Errata 547

32.47Case, pattern (supersedes P1364 26.6.36)

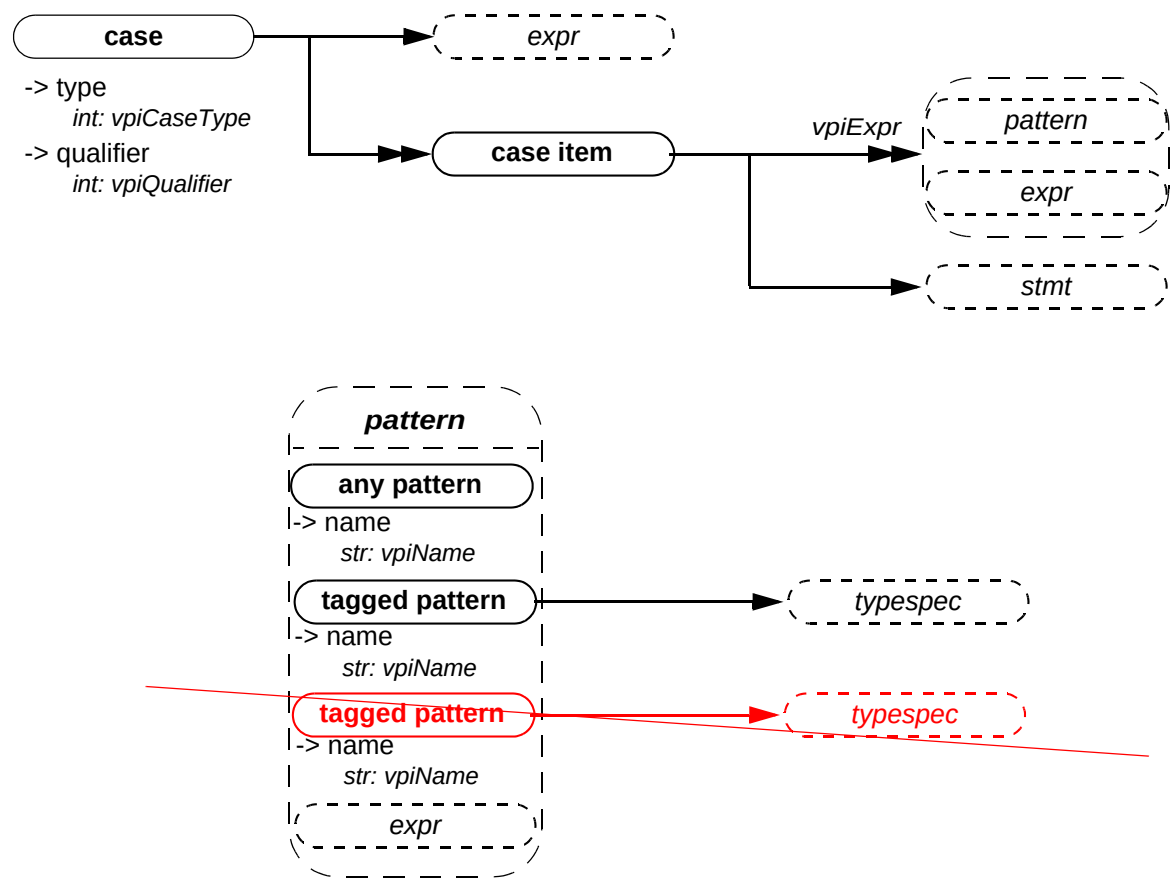
Delete the second tagged pattern and second typespec

Add structPattern and a arrow to pattern.

Add an arrow to pattern from a tagged pattern.

The new diagram should look like:
